# Technical BULLETIN

## SAFETY RECALL

### 2015~2020-MODEL YZF-R3 AND 2020-MODEL MT-03 MOTORCYCLES, AND 2018~2020-MODEL XMAX SCOOTERS FACTORY MODIFICATION CAMPAIGN – Rear Reflector Assembly

#### 2015~2018 YZF-R3

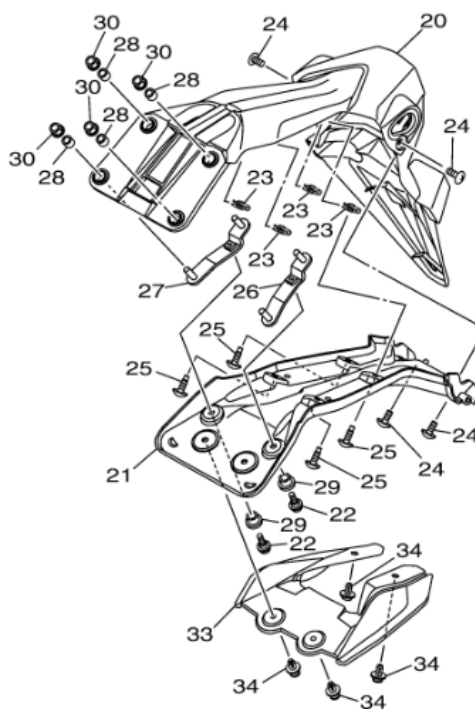
1. To prevent damage, cover any painted parts near the mud guard.
2. Remove the mud guard assembly by removing the following hardware:

- 34 - Bolt 10mm (4pc)
- 33 - Rear Fender Cover
- 24 - Bolt (2pc), Torque: 3.8Nm (0.38 kgf-m, 2.8 lb-ft)
- 24 - Bolt (2pc), Torque: 3.8Nm (0.38 kgf-m, 2.8 lb-ft)
- 25 - Bolt (4pc), Torque 2.5Nm (0.25 kgf-m, 1.8 lb-ft)
- 22 - Bolt (2pc), Torque 6.5Nm (0.65 kgf-m, 4.8 lb-ft)
- 29 - Damper (2pc)
- 21 - Fender Bracket

**2019~2020 YZF-R3 and 2020 MT-03**

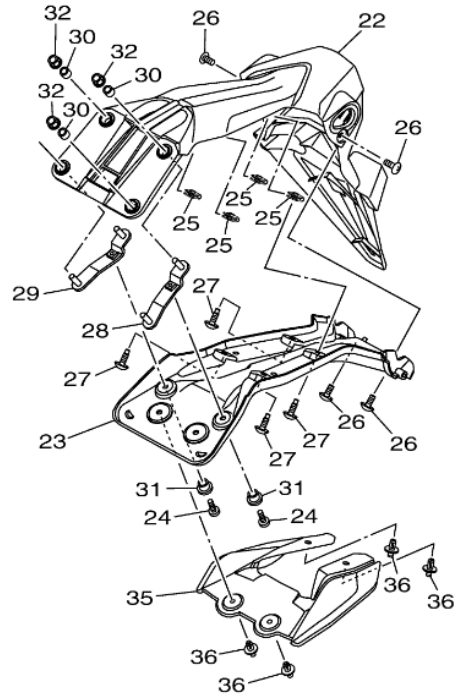
- 36 - Bolt 10mm (4pc)
- 23 - Rear Fender Cover
- 26 - Bolt (2pc), Torque: 3.8Nm (0.38 kgf-m, 2.8 lb-ft)
- 26 - Bolt (2pc), Torque: 3.8Nm (0.38 kgf-m, 2.8 lb-ft)
- 27 - Bolt (4pc), Torque 2.5Nm (0.25 kgf-m, 1.8 lb-ft)
- 24 - Bolt (2pc), Torque 6.5Nm (0.65 kgf-m, 4.8 lb-ft)
- 31 - Damper (2pc)
- 23 - Fender Bracket

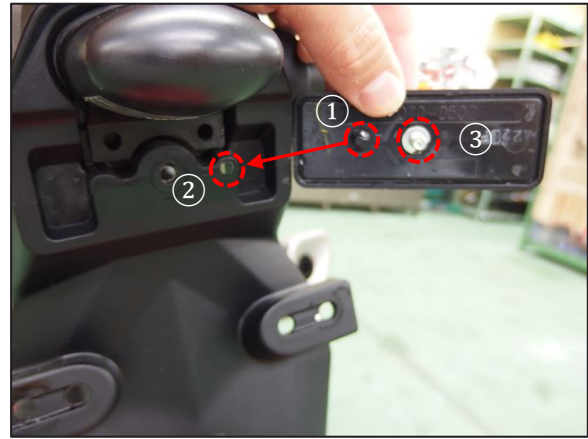
4. Remove the rear reflector ① and replace it with the new reflector assembly kit. The nut ② and washer ③ will be reused.

5. Install the new rear reflector.
  - Match the locating pin on the reflector ① with the locating hole ② on the mud guard assembly.
  - Install the original washer and nut on the rear reflector assembly ③.
  - Tighten the rear reflector mounting nut to the specified torque: 1.5Nm (0.15 kgf-m, 1.1 lb-ft).
  - Reinstall the mud guard assembly in the reverse order. Tighten all mounting hardware to the torque specified in step 2.

### REPLACE REAR REFLECTOR (XMAX)

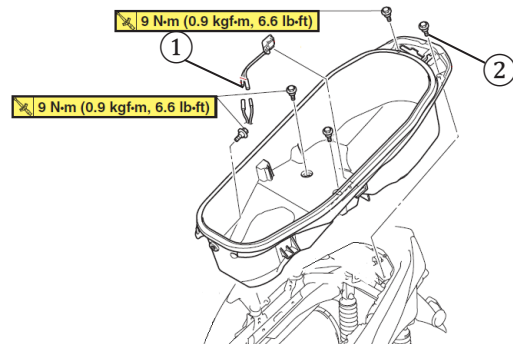
2. Remove the box (trunk) assembly:
  - Disconnect the baggage lamp ① and remove the five retaining bolts ②. The bolts will be reused.
  - Spread the lower side cover (left side shown) ③ slightly outward. Release the box lip ④ and remove the box assembly.

3. Remove the mounting bolts for the rear side cover ⑤ and then remove the rear side cover.

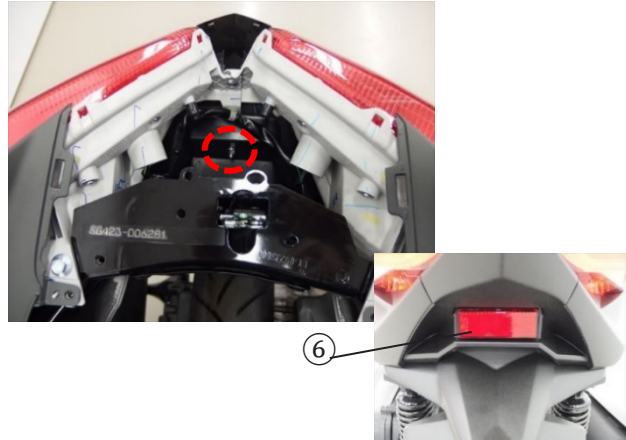
4. Remove the rear reflector nut and remove the rear reflector ⑥.

5. Install the replacement reflector assembly kit.
- Match the locating pin on the rear reflector assembly with the mating hole on the cowling assembly.
  - Install the original washer and nut and tighten to 1.5Nm (0.15 kgf-m, 1.1 lb-ft).
  - Reinstall the rear side cover and box in reverse order. Tighten all bolts and nuts to 1.8Nm (0.18 kgf-m, 1.3 lb-ft).
6. Discard the old reflector to prevent it from being accidentally reused.
